SERVICE BULLETIN

DATE: 12 FEBRUARY 1998

CABIN SEAT RESTRAINT ASSEMBLY REPLACEMENT

All MD600N Series Helicopters, serial numbers RN0003 thru RN0023.

Figure 1. Cabin Seat Restraint Replacement

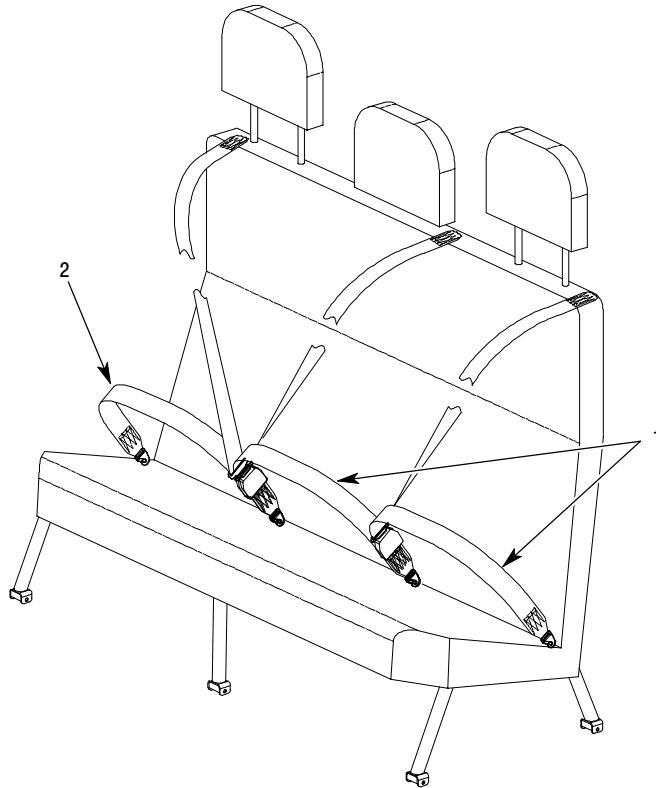
To provide longer mid cabin seat restraints. Failure to perform the requirements of this Bulletin may cause some passengers discomfort when the seat restraints are engaged or may not allow some passenger to engage the seat restraints at all, which may result in injury to passengers during flight operations.

- (1). Remove the 600N6521-501 cabin seat restraint assembly and install a 600N6521-503 cabin seat restraint assembly per instructions contained in the Handbook of Maintenance Instructions (CSP-HMI-2).
- (2). Remove the 600N6521-502 cabin seat restraints assembly and install 600N6521-504 cabin seat restraint assemblies per instructions contained in the Handbook of Maintenance Instructions (CSP-HMI-2).

NOTE: Webbing should be installed thru a loop on the side of the aft cabin seats.

ITEM 1: 600N6521-504
ITEM 2: 600N6521-503
